Re: **Laura Heights – Minor Amendment**

MDP # 870-E & PUD 05-035F

P.U.D. 05-035F MINOR AMENDMENT, AMENDING PUD 05-035E
 M.D.P. 870-E MINOR AMENDMENT, AMENDING MDP 870-D

PUD & MASTER DEVELOPMENT PLAN
 LAURA HEIGHTS
 BEXAR COUNTY, TEXAS

GATE DETAIL "1"

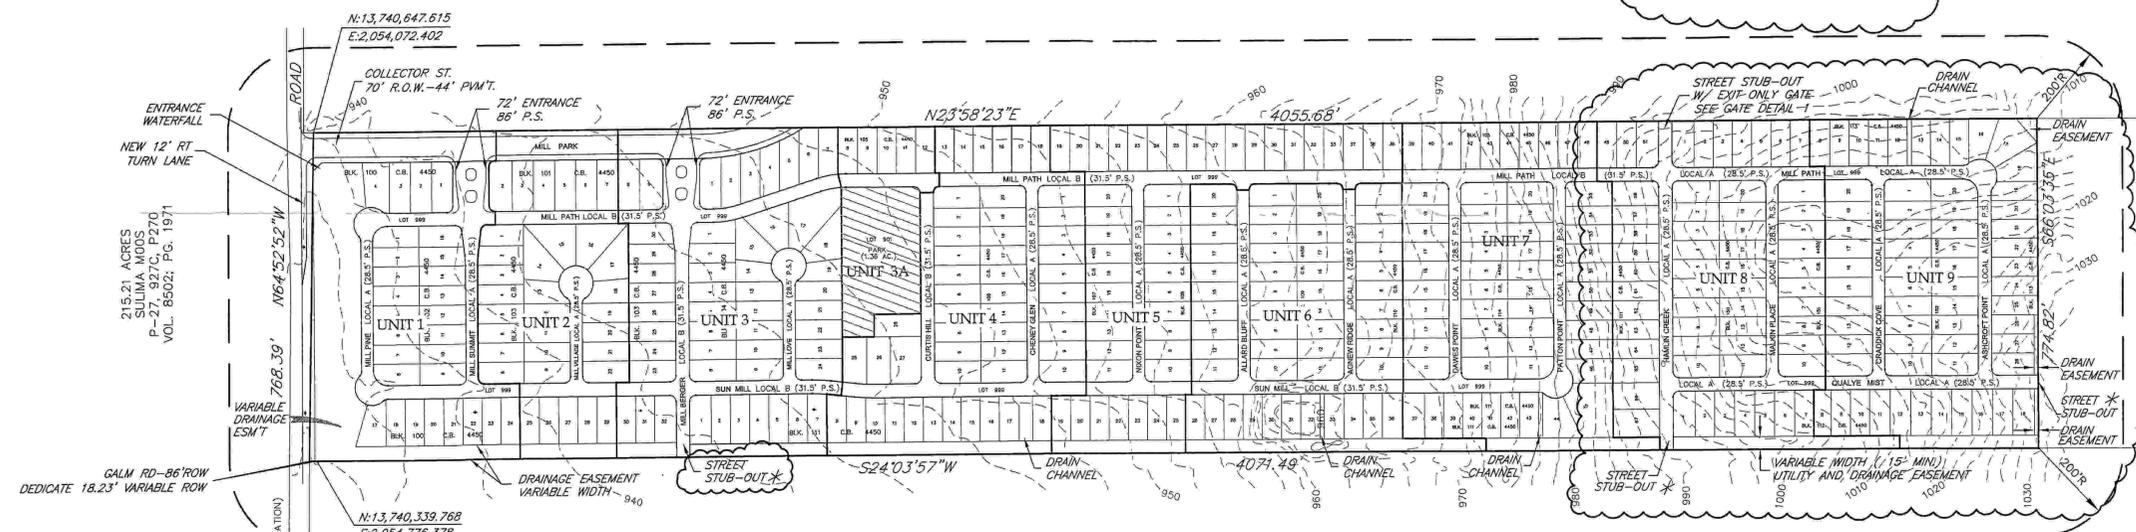
1. Address the gating on all stub out streets.

NOTE: Mill Berger is constructed without a gate. If the adjacent land is developed, it will be required to connect to this street. In the event that this is a public street, no accommodations for a gate will likely be provided.

1. Will the proposed local A (Hamlin Creek) be able to handle the projected traffic? Provide a breakdown.
2. Address the gating on all stub out streets.

NOTE: Mill Berger is constructed without a gate. If the adjacent land is developed, it will be required to connect to this street. In the event that this is a public street, no accommodations for a gate will likely be provided.

CHANGES INCLUDE REVISING THE STREET SECTIONS IN UNITS 8 & 9 FOR HAMLIN CREEK, QUAYLE MIST, ASHCROFT POINT AND MILL PATH FROM HAMLIN CREEK TO ASHCROFT POINT.
 * GATES WILL BE REQUIRED WHEN NEW DEVELOPMENT CONNECTS TO THE STUB OUT STREETS SHOWN ON THIS PLAN.
